TO: Chairman Dr. Romona Jackson Jones, Douglas County
ATTN TO: Phil Shafer, Zoning Administrator, Douglas County
FROM: Mike Alexander, Director, ARC Center for Livable Communities
RE: Development of Regional Impact (DRI) Review

Name of Proposal: The Trails DRI 3544

Description: A DRI review of a proposal to construct a mixed-use development with commercial, restaurant, office, residential, and open-space elements on a 59 acre site generally located south of Highway 92 in Douglas County. Currently the site is mostly undeveloped with natural forest and several streams including Crooked Creek. Components include a 112 room hotel, 43,500 SF of commercial/restaurant space, 160,000 SF of office space, 365 multi-family units, and 98 townhomes.

DRI-1

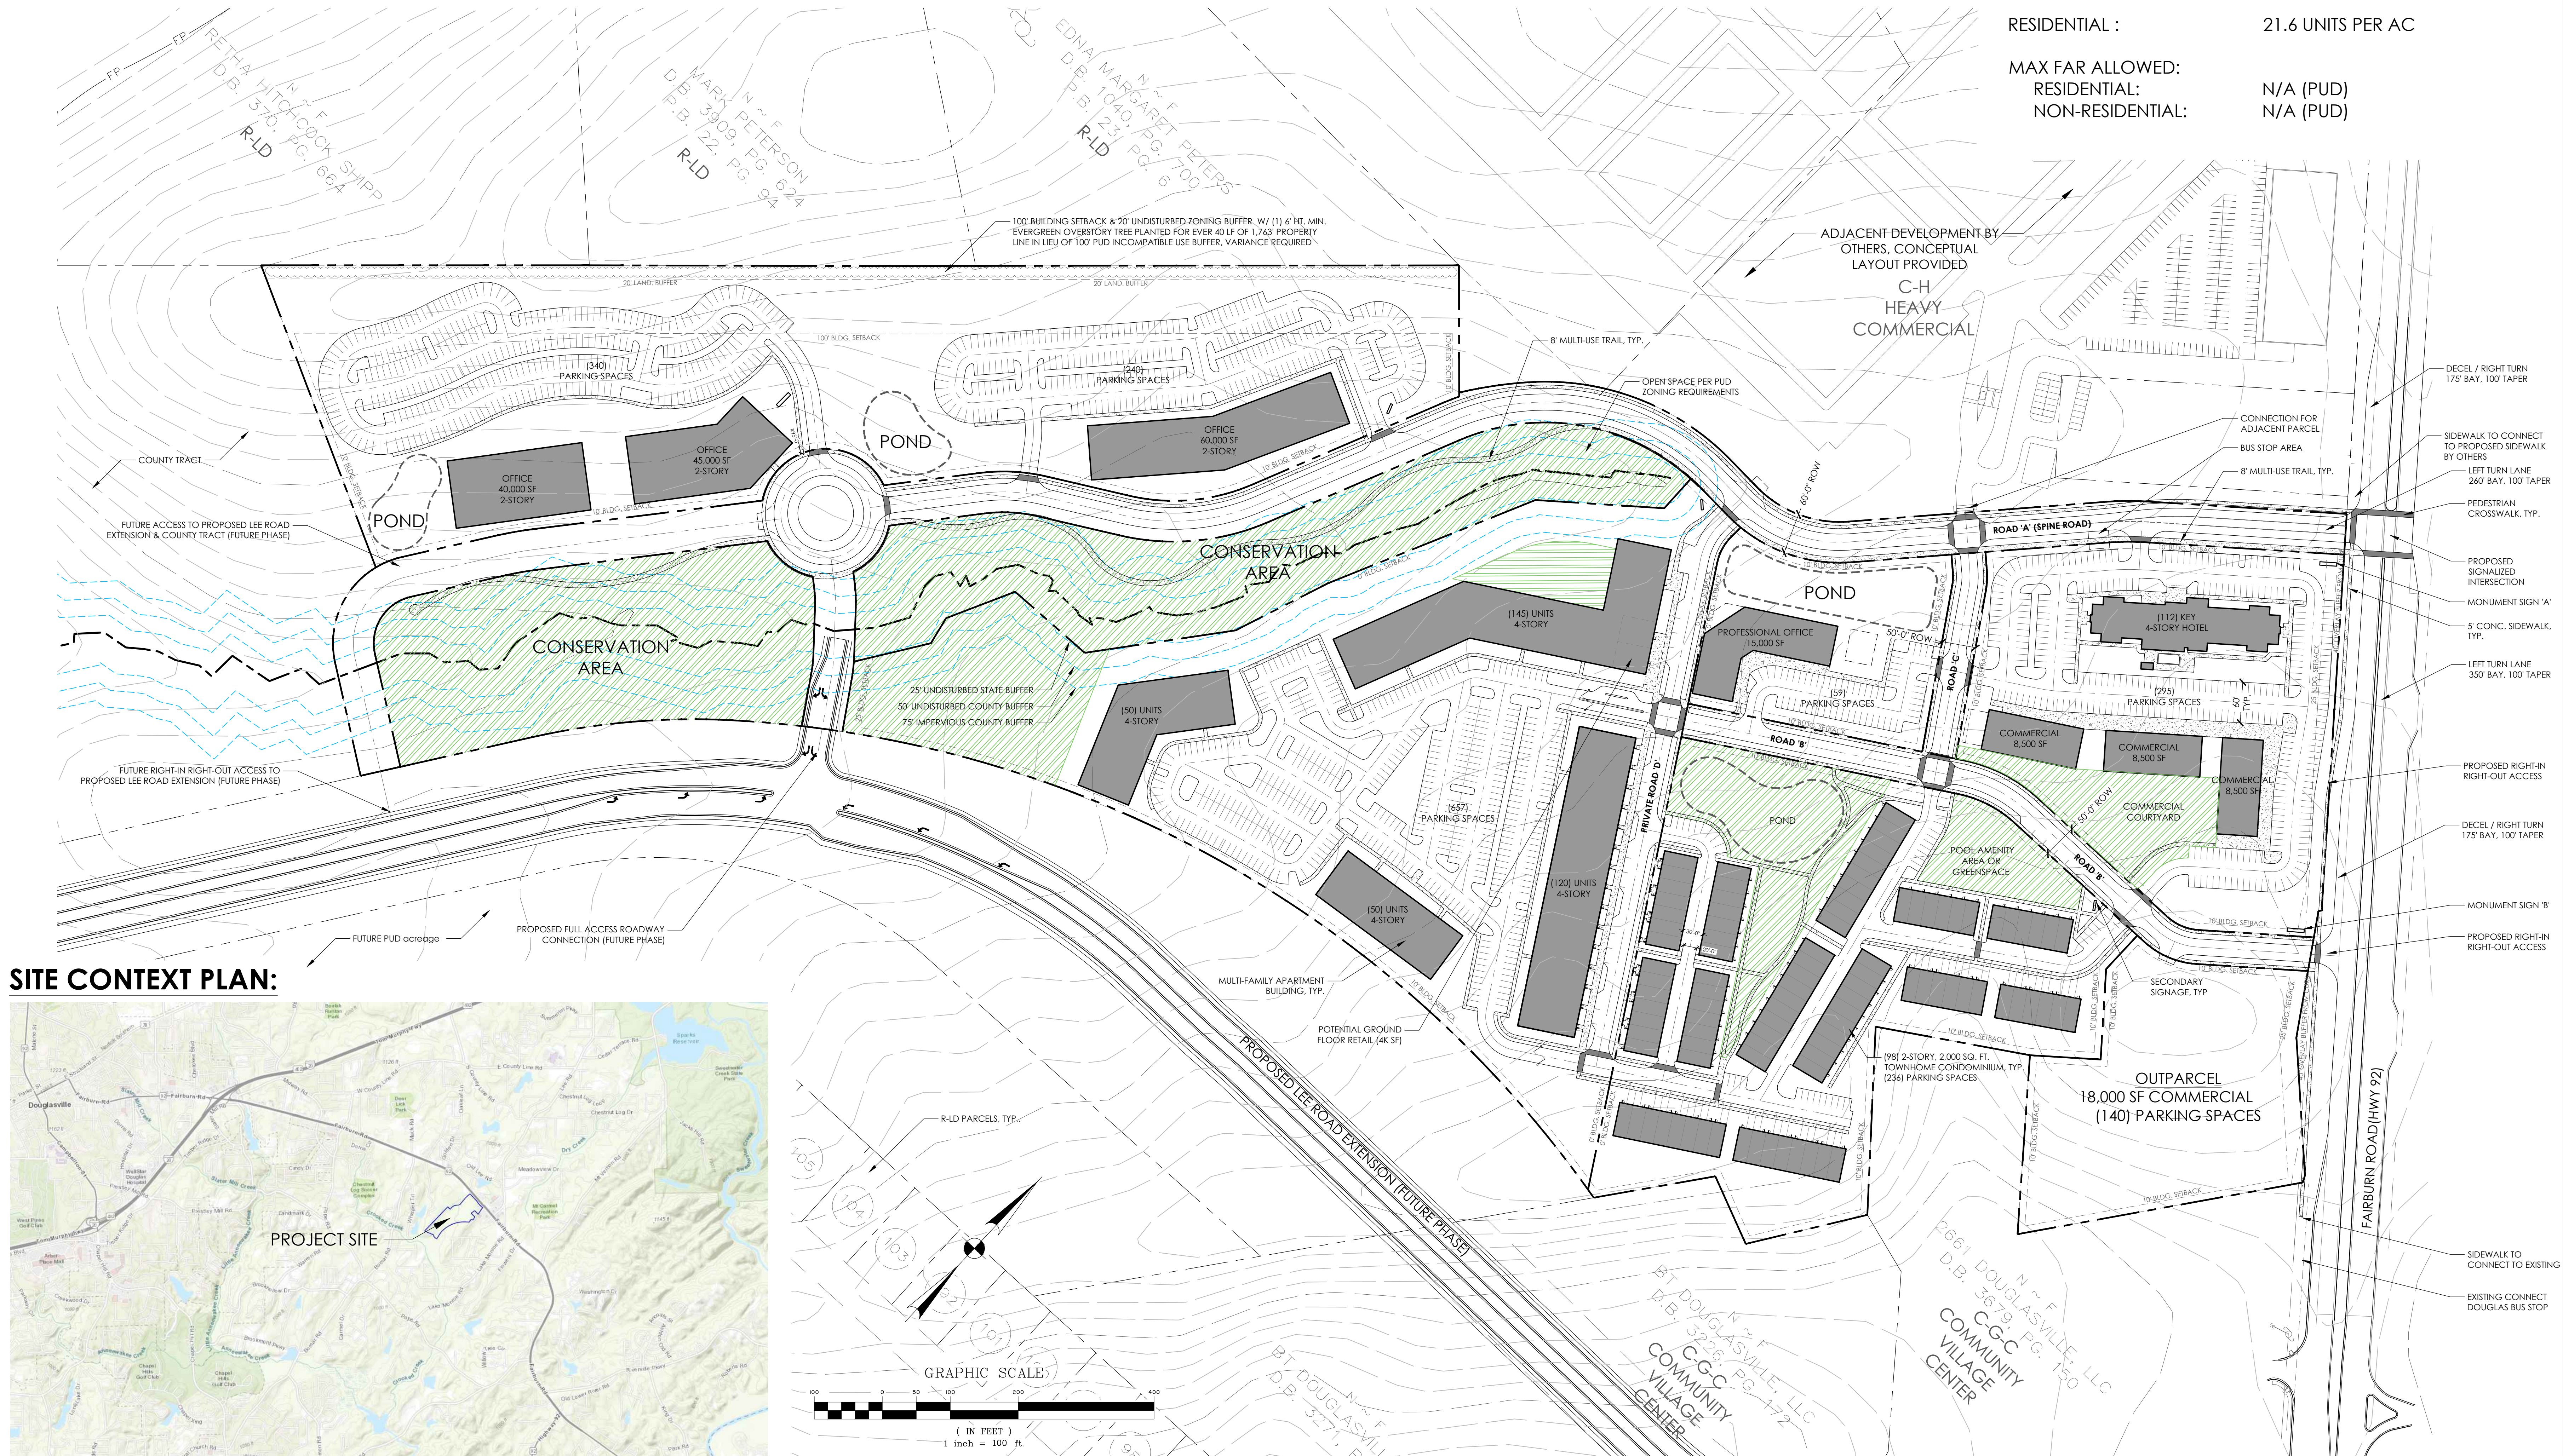
A number of project elements cross or intrude into labeled stream buffers including two road crossings, portions of the multi-use trail, and several multi-family buildings; stream crossings are allowed under the City stream buffer ordinance while other intrusions may require variances.

Incorporation of green stormwater and heat island mitigation approaches for the approximately 1,967 car parking spaces proposed would be supportive of regional environmental policies.

The proposed multi-use trail is consistent with regional policies promoting safe dedicated routes for recreational and transportation related pedestrian and bicycle trips. Ideally the trail will be aligned with any external trail connections. A potential alternate route for the western part of the trail away from Road A through a more central area of the project could provide a more inviting user experience as well as activation of the ground floor commercial uses.

Care should be taken to ensure that the constructed development provides an interconnected, functional, clearly marked and comfortable pedestrian experience on all driveways, paths, entrances, and parking areas. To the maximum extent possible, new driveways and intersection corners where pedestrians will cross should be constructed with minimal curb radii to reduce speeds of turning vehicles and decrease crossing distances for pedestrians.

The USGS coverage for the project area does not show any blue-line streams on or near the project property. The project plans show an unnamed tributary to Crooked Creek, which is a tributary to Anneewakee Creek, crossing the property from northeast to southwest. The site plan shows and identifies both the 50-foot undisturbed stream buffer and additional 25-foot impervious setback required under the City's Stream Buffer Ordinance, as well as the State 25-foot State Erosion and Sedimentation Control buffer along the stream. The main access road crosses the buffers at the headwaters of the stream and runs along the edge of the 75-foot buffer, with a several small intrusions into the 75-foot buffer along its route. Two proposed stream crossings by access roads are shown, as well as an eight-foot multi-use trail within the buffer. Two apartment buildings on the eastern side of the stream are shown at the stream buffer limits in several places. While the stream crossings are allowed under the City stream buffer ordinance, other intrusions may require variances. Any other unmapped streams on the property may also be subject to the City buffer ordinance. Any other State waters identified on the property may also be subject to the State 25-foot Sediment and Erosion Control buffer.

The current site is mostly wooded natural area. The project laudably proposes nearly 7 acres of conservation area. Designation of some additional conservation area would increase the project's alignment with applicable Developing Suburbs recommendations which call for "additional preservation of critical environmental locations and resources, as well as agricultural and forest uses."

The project can further support The Atlanta Region's Plan by incorporating other aspects of regional environmental policy including green infrastructure and/or low-impact design – such as pervious pavers, rain gardens, and vegetated swales – in the large proposed surface parking areas and site driveways. No EV charging stations are proposed; inclusion of some EV charging stations would be supportive of regional EV infrastructure development plans.
